ADDENDUM No. 2 – March 27, 2026

Tufts Vet Tech Clinic Renovation

Worcester Technical High School
1 Officer Manny Familia Way, Worcester, MA 01605

1 ADD-2 - IDF Room D319A
1/8" = 1'-0"

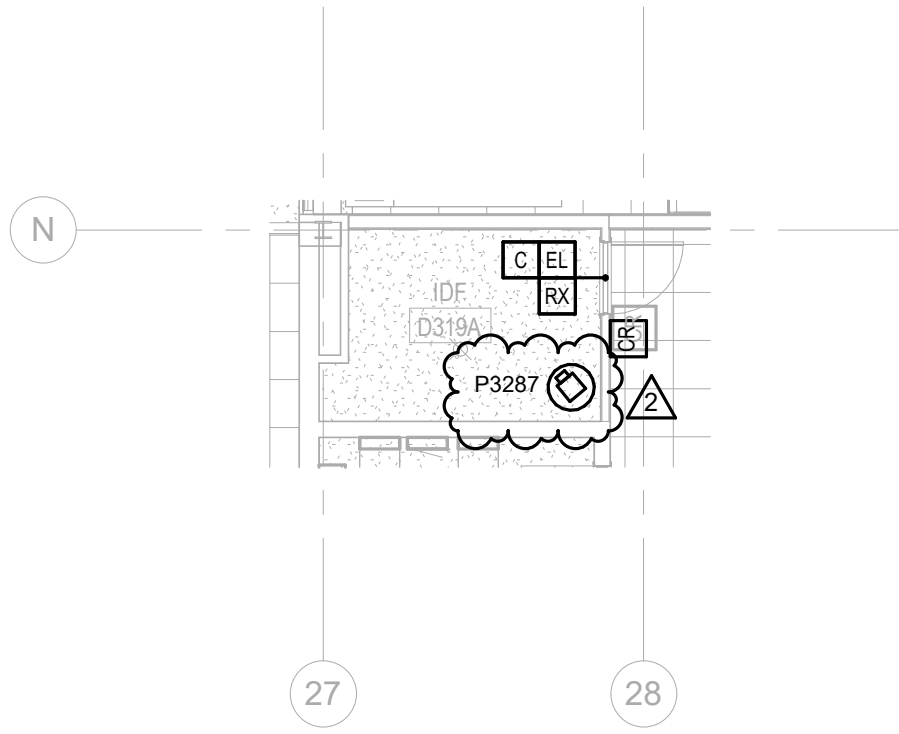
Add: Camera location to IDF Room D319A as shown in sketch ADD-2/E-001.

2 ADD-2 - Teaching Hub D322
1/8" = 1'-0"

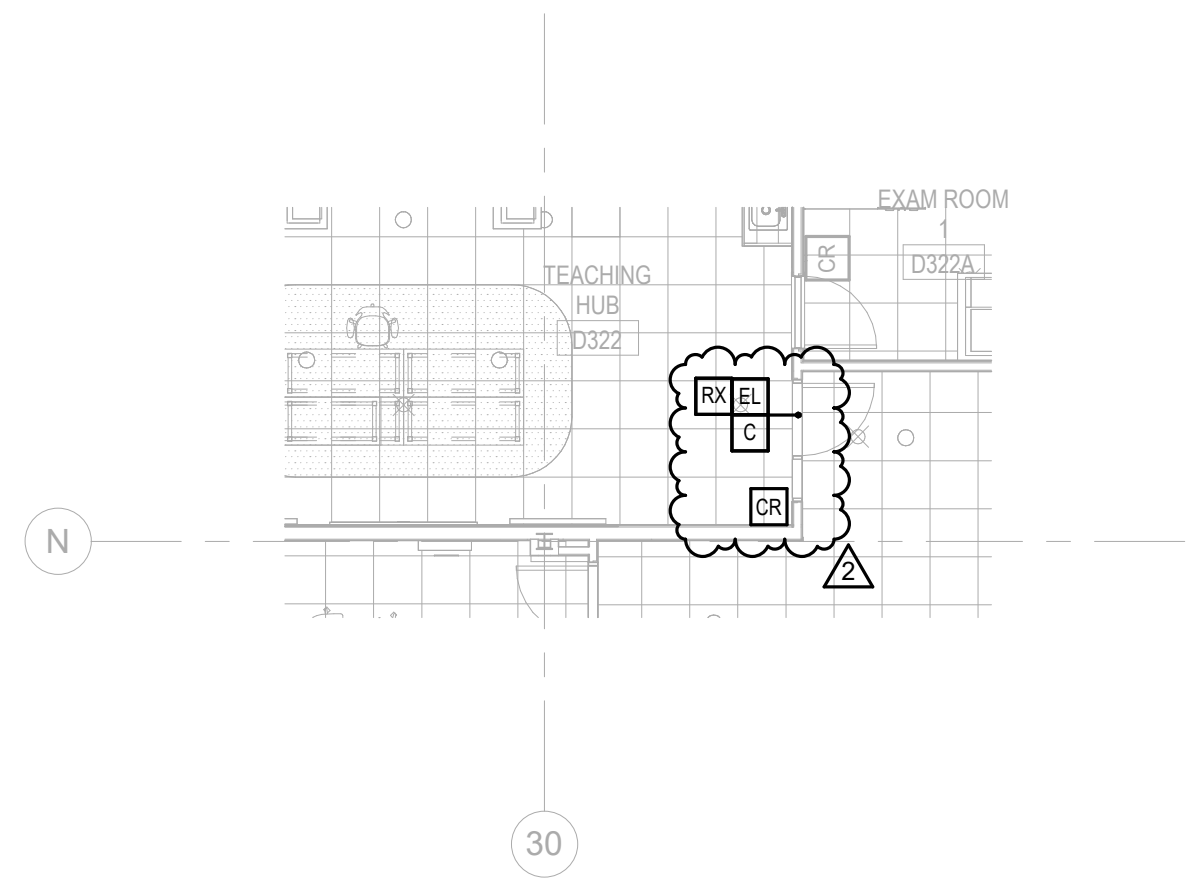
Add: Electronic Hardware devices and wiring at door opening D322 in Teaching Hub D322 as shown in sketch ADD-2/E-001.

③ FURNISH AND INSTALL (1) CATEGORY 6A CABLE TO EXISTING DATA CABINET. TERMINATE IN NEW PATCH PANEL AND PROVIDE TESTING. PROGRAM THE VES SUCH THAT WHEN THE CALL BUTTON IS PRESSED, THE AXIS A8207-VE MK II INITIATES A SIP CALL TO A PRE-CONFIGURED SIP PHONE MODEL 2N D7A (OR GROUP OF PHONES) CONNECTED TO A PBX SERVER, ALLOWING THE PERSON WHO ANSWERS THE CALL TO SEE VIDEO FROM THE DOOR STATION. FROM THE SIP PHONE'S INTERFACE, THE USER CAN THEN ENTER A CODE ON THE PHONE TO TRIGGER THE AXIS A8207-VE MK II 'S BUILT-IN RELAY, WHICH IN TURN SIGNALS THE ACCESS CONTROL PANEL TO UNLOCK THE DOOR. FURNISH AND INSTALL A9801 SECURITY RELAY.

ADD-2
E-002

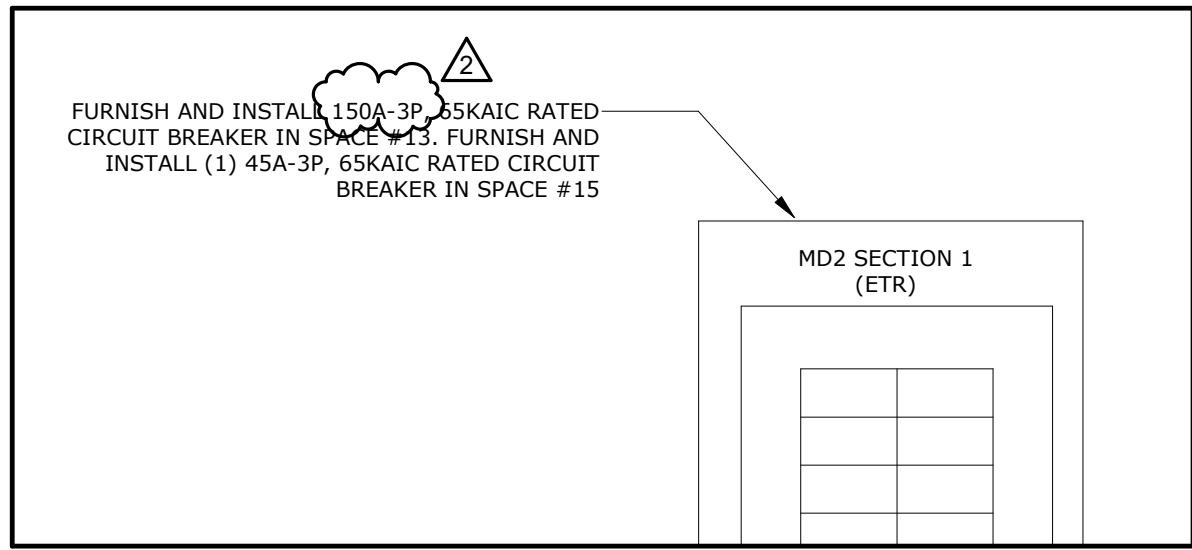
Revise electrical requirements for DOAS-1 and DOAS-2 as shown in attached sketch ADD-2 /E-002.

TAG	DESCRIPTION	FLA	MCA	MOCP	VOLTAGE	POLES	DISC./FUSE	PANEL	CKT #	FEEDER	TAG
DOAS-1	ROOFTOP ENERGY RECOVERY UNIT	106.4	133 A	150 A	480 V	3	SEE NOTE #1	MD2	13	2" C, 3-1/0, #6G	DOAS-1
DOAS-2	ROOFTOP ENERGY RECOVERY UNIT	34.4	43 A	45 A	480 V	3	SEE NOTE #1	MD2	15	1" C, 3#6, #10G	DOAS-2

NOTE:
 1. PROVIDE POWER FOR FACTORY-INSTALLED UNFUSED DISCONNECT SWITCH. EQUIPMENT TO BE FURNISHED BY DIVISION 23.
